ADDENDUM #04

DATE:	September 29, 2023	PROJECT NO.:	Project # 20229080 CRSA Project # 21-031
TO:	Gramoll Construction 155 S. 750 W. North Salt Lake, UT 84054	PROJECT:	Rio Grande Depot Seismic 300 S. Rio Grande St. SLC, UT 84101

This Addendum forms a part of the Contract Documents and modifies the original Bid Documents dated October 3, 2022 as noted below. Acknowledge receipt of this Addendum in the space provided on the Bid Form. Failure to do so may subject the Bidder to disqualification.

A1 FOOTING & FOUNDATION PLAN - OVERALL
SB100 SCALE: 1/16" = 1'-0"

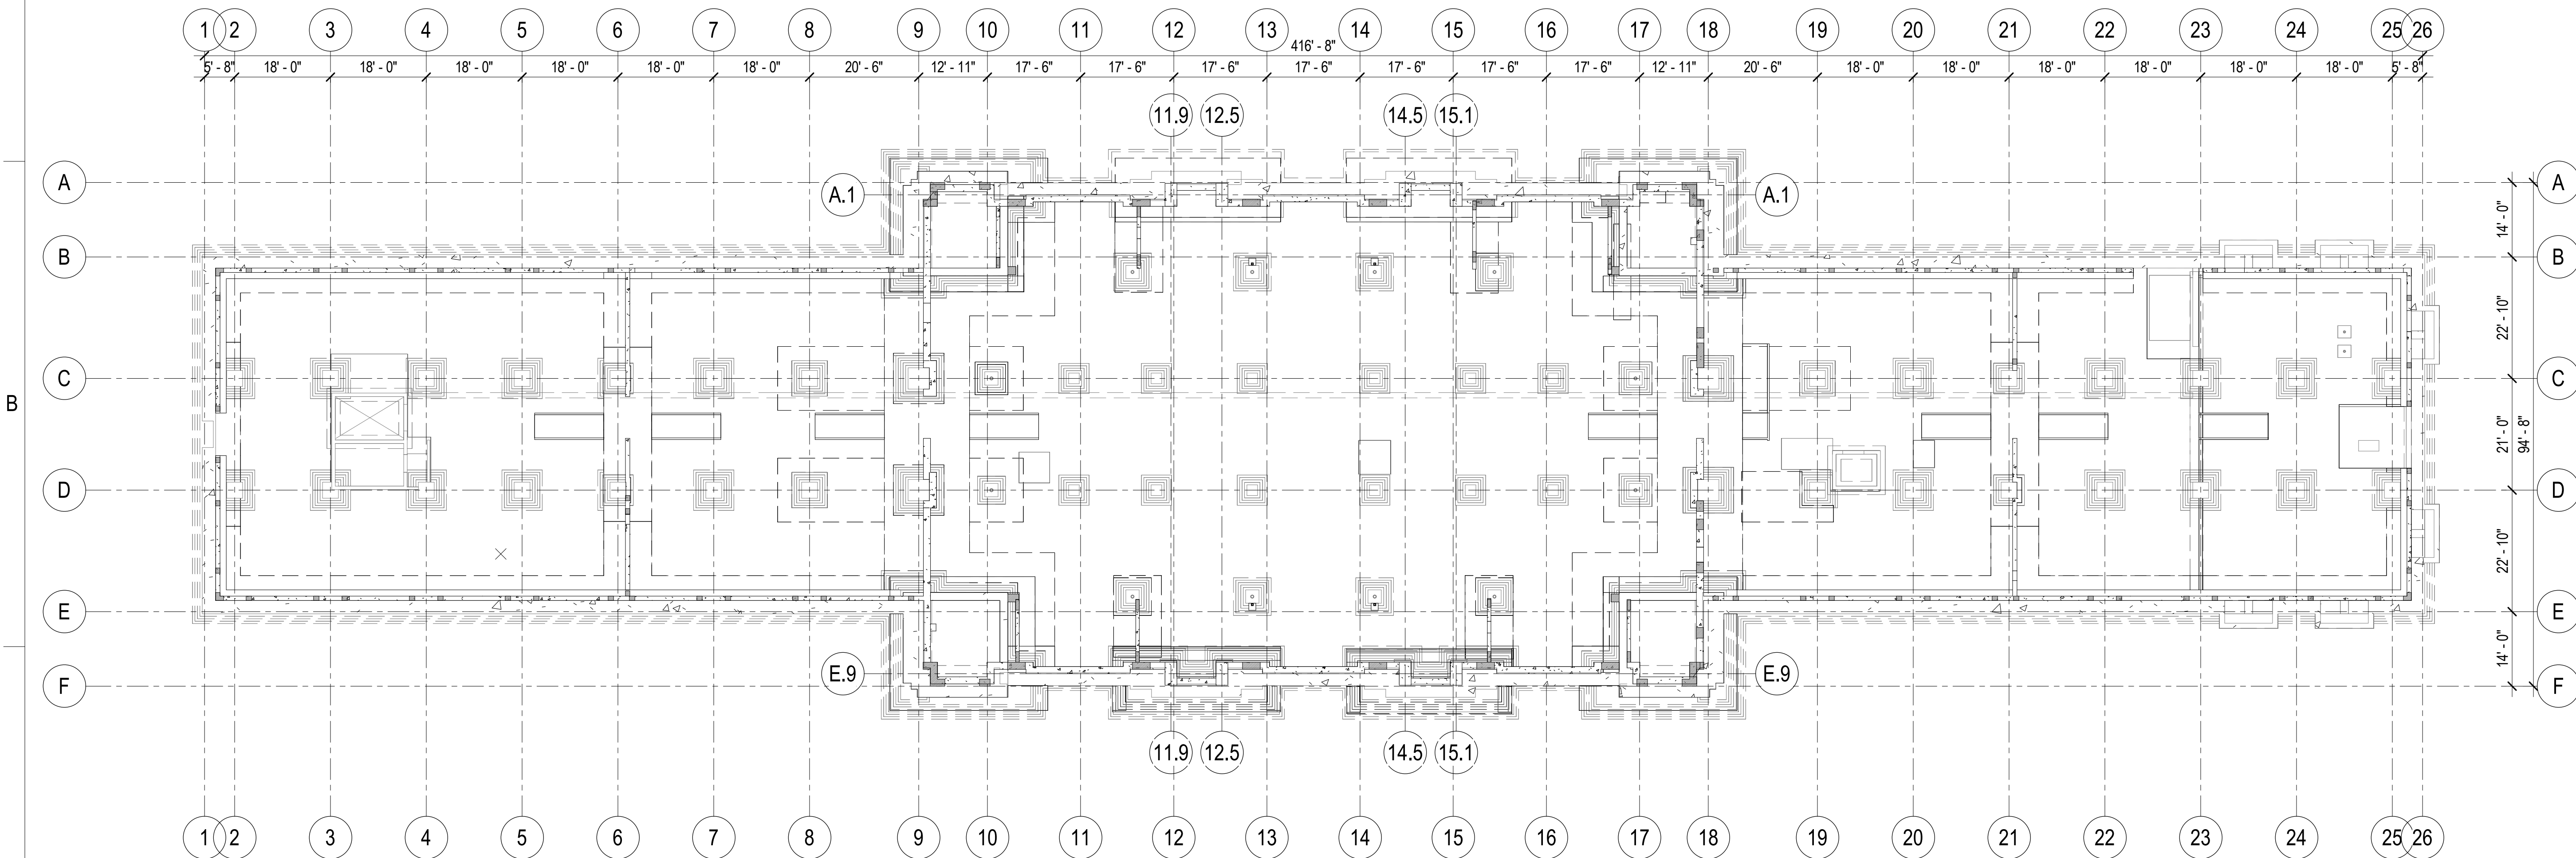
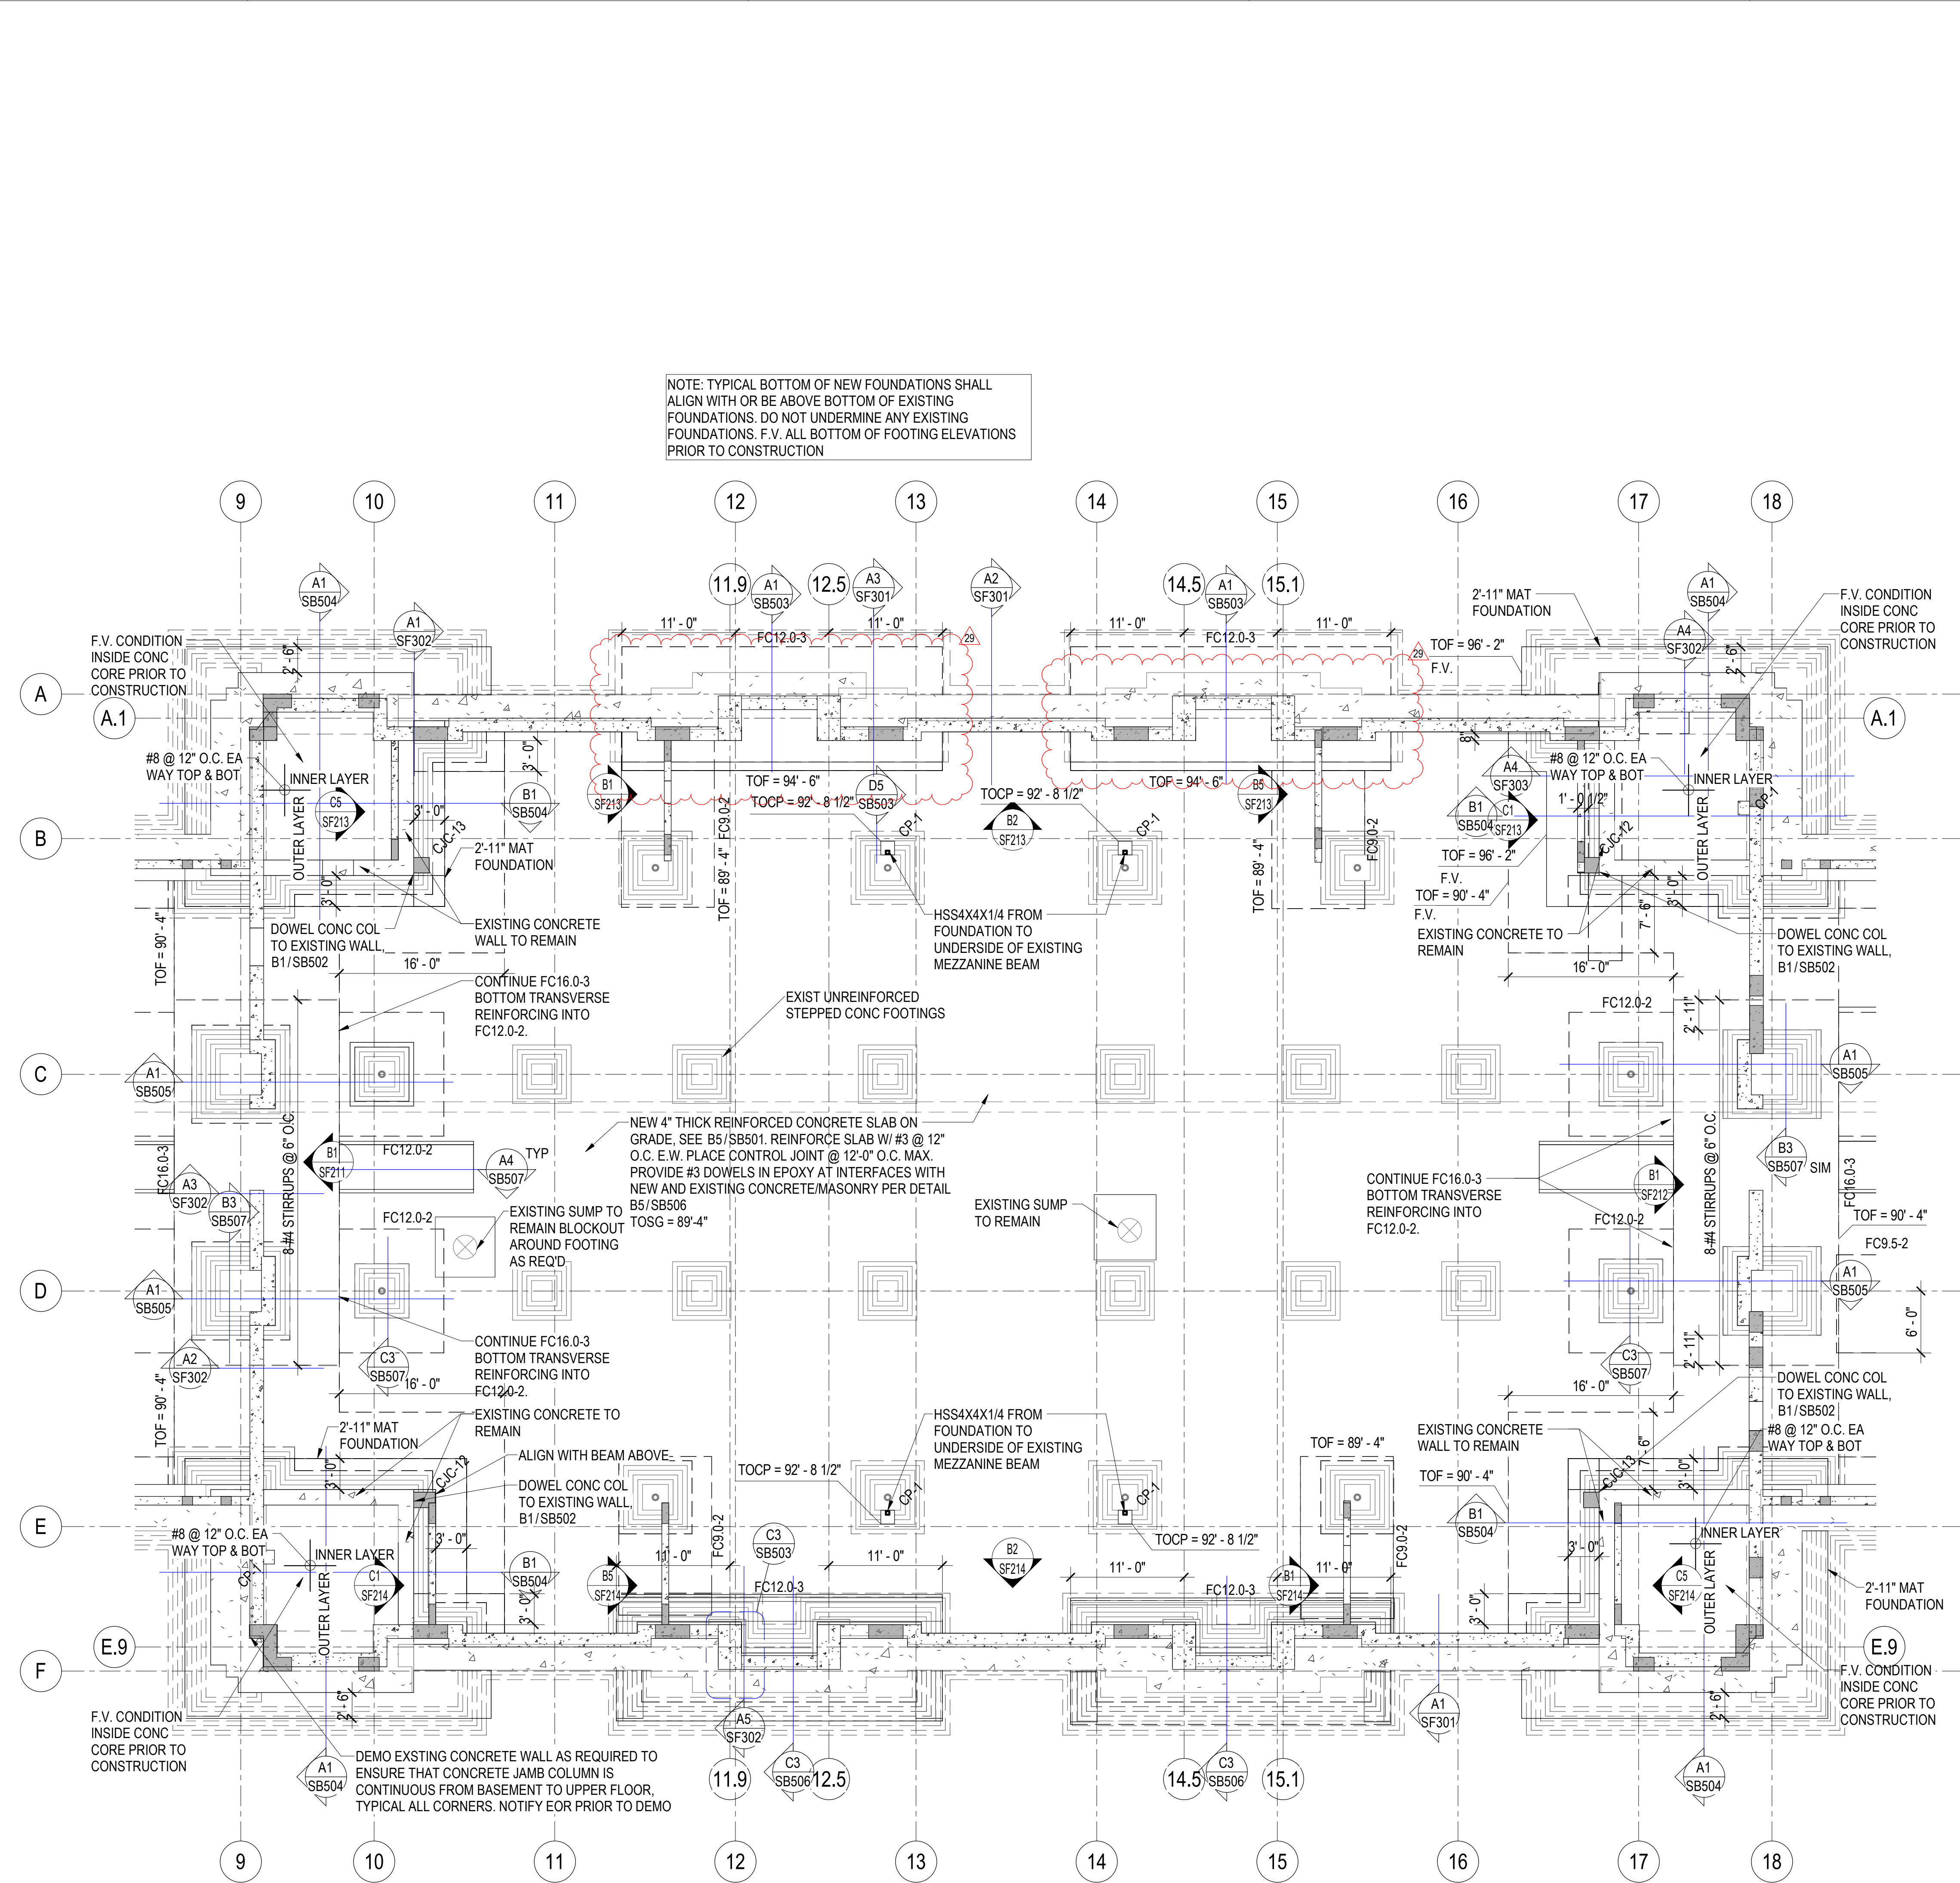
SHEET – DESCRIPTION OF CHANGE	
SE002	Added metal grating to GSN
SB100	Existing concrete shelf shown
SB100B	Existing concrete shelf shown and details revised
SB502	Wording clarified in detail B3/Sb502
SB503	Detail revised for existing concrete shelf
SB511	Added detail callouts on typical elevation
SB604	Added note to stirrups of CB-10
SF201	Revised to show updated catwalk location
SF202	Revised to show updated catwalk location
SF203	Revised to show updated catwalk location
SF301	Existing concrete shelf shown in A3/SF301, drafting revisions to C4/SF301
SF501	Minor revisions to details based on field verification
SF502	Minor revisions to details based on field verification
SF503	Minor revisions to details based on field verification
SF504	Drafting error revision
SF511	Minor revisions to details based on field verification

C2 CONCRETE WALL TO CONCRETE FOOTING
SB502 NO SCALE

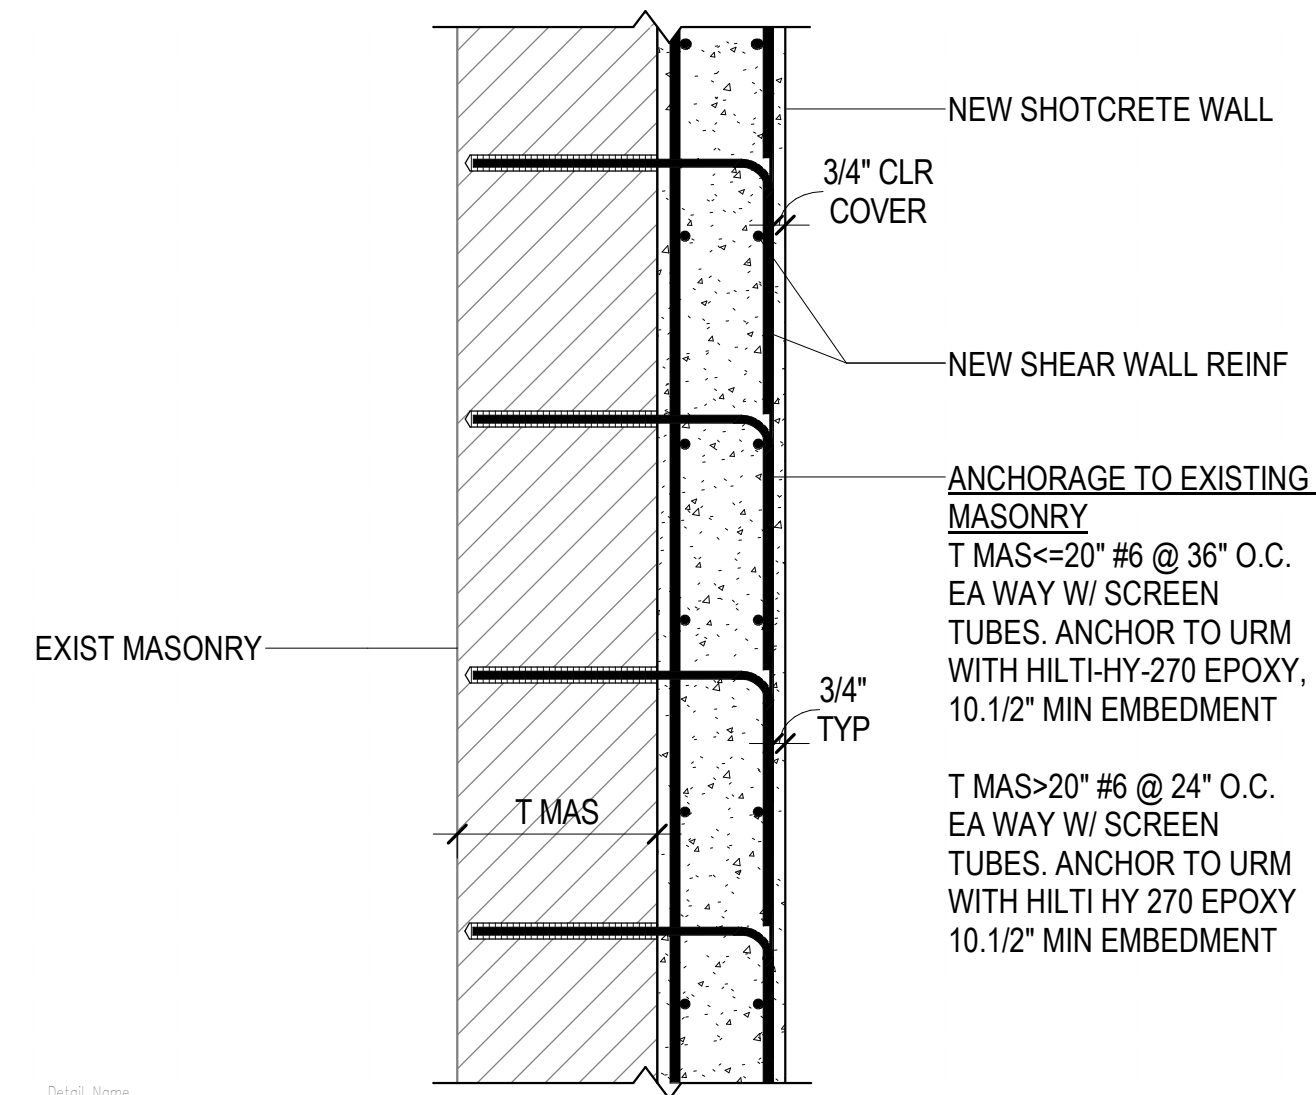
a) Answer: Wording has been clarified in addendum. - Reaveley
- IX-8 Question: On sheet SB 502 detail C2 indicates roughen surface of the footing pours. Is it the engineer's intent to roughen all of the surfaces that the footings and walls pour against existing concrete surfaces or just the footings?

a) Answer: Surface roughness on detail only applies to extent of footing overlap with existing wall, does not extend on wall surface above. - Reaveley
- IX-9 Question: Does the GC cover cost to maintain the temperature above 40 degrees for the entire interior of the building throughout the winter? Does the concrete subcontractor need to cover concrete mix additives throughout the winter as well as all cost to prevent freezing outside of the building during placements and curing?

B1 TYPICAL SHOTCRETE WALL TO EXISTING MASONRY OR CONCRETE
SB502 NO SCALE

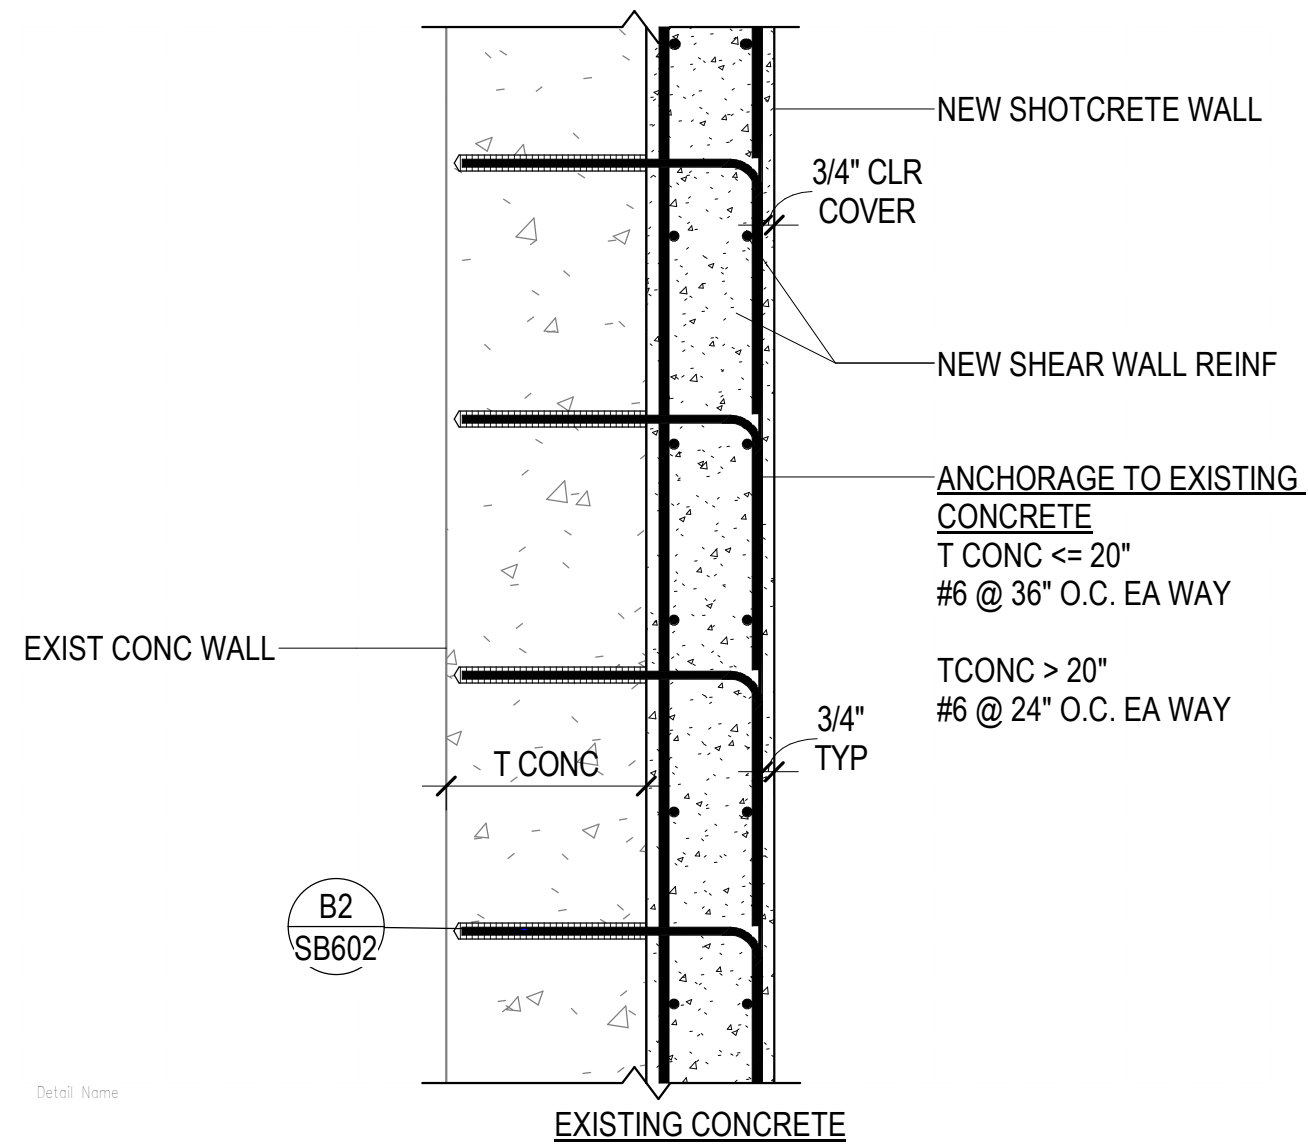
- a) Answer: The out of plane wall force is $0.43 \cdot W$ (W = weight of wall and cladding) at the BSE-2E hazard level. - Reaveley
- IX-24 Question: The regularly spaced epoxy anchors in detail B1/SB502 call for 10 1/2" min. embedment. Is it appropriate to achieve a minimum embedment within 5 inches of the exterior face so that no more than 1 wythe is not anchored back to the concrete or shotcrete strengthening?

- IX-25 Question: Is the extension of the dowels in B1/SB502 beyond the 90 degree bend a standard hook?
- a) Answer: Typical 90 degree hook is required. - Reaveley

- a) Answer: Due to the presence of header courses throughout the structure, it is not necessary to achieve a minimum embedment with 5" of the exterior face of masonry. - Reaveley
